©Kawasaki Motors Corp 1974 Printed in USA

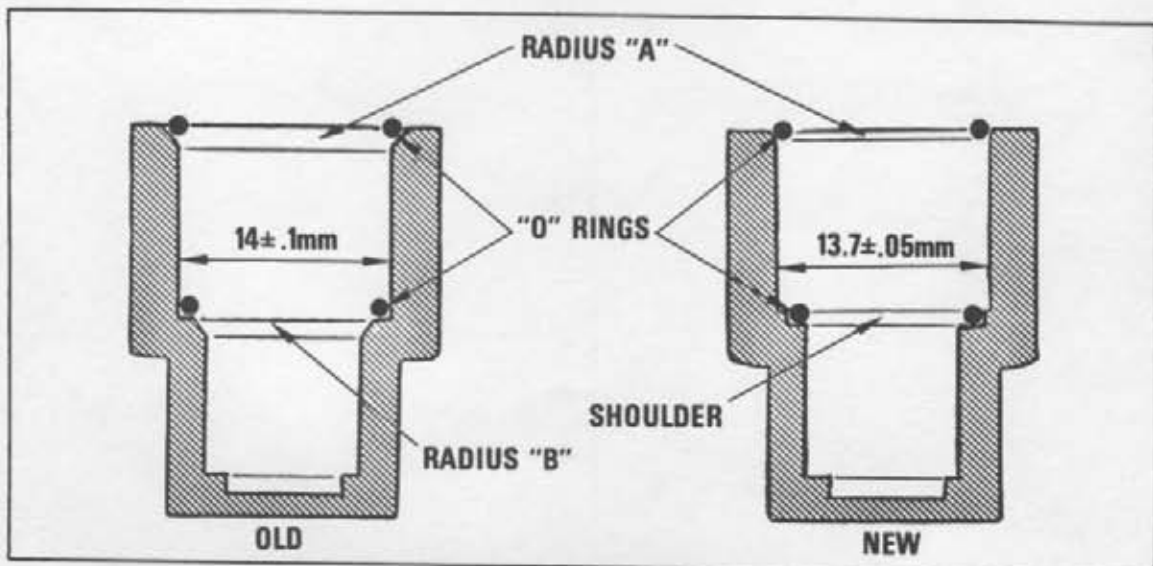
This problem has been traced to faulty O-ring seating in the oil pump end cover. After installation, the two O-rings inside the cover shrink approximately .1 to .2mm in diameter. This shrinkage allows oil to seep around the seals and into the end cover chamber. From this point, the excess oil is pumped to the right cylinder, which is serviced by the end cover orifice, resulting in smoking and premature spark plug failure.

**NOTE:** *On some very early S2's the end cover chamber was connected to the center cylinder, rather than the right. On all later models ('72, '73) the end chamber is connected to the right cylinder.*

- A. Radius "A" has been decreased in depth to give the O-rings less "squish" space, making a tighter seal.
- B. Radius "B" has been eliminated altogether to improve the seal at that point.
- C. The internal diameter of the chamber has been decreased from  $14 \pm .1\text{mm}$  to  $13.7 \pm .05\text{mm}$  to compensate for O-ring shrinkage.
- D. A slight shoulder has been added to the base of the new chamber to further compress the O-ring.
